# Access Compliance Report

## Public Rights-of-Way

### (Curb Ramps)

| Intersection ID: 27452                  | Main Street: BALLANTYNE_COMMONS_PY | Cross Street: BALLANTYNE_CORPORATE_PL   | Location: SE           |

| ADA ID: 0C99524EA68F                    | Ramp Type: Perp                    | Initial Pass/Fail: Fail                 | Overall Compliance: No |

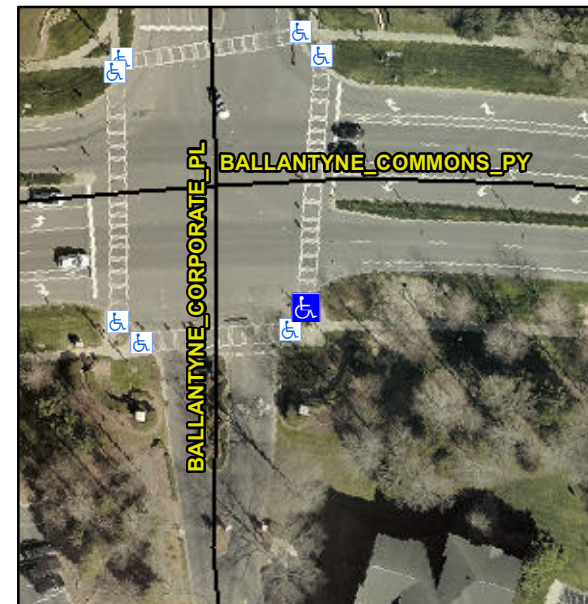
**Not Found, R304.5.1, R304.2.2**

| Compliance | Description           | Data  | Compliance | Description                 | Data |
|------------|-----------------------|-------|------------|-----------------------------|------|
| N/A        | Ramp Length (in)      | 134.0 | No         | Ramp Slope (%)              | 13.3 |
| No         | Ramp Width (in)       | 34.0  | Yes        | Ramp XSlope (%)             | 2.0  |

**Remove & Replace Entire Ramp.**
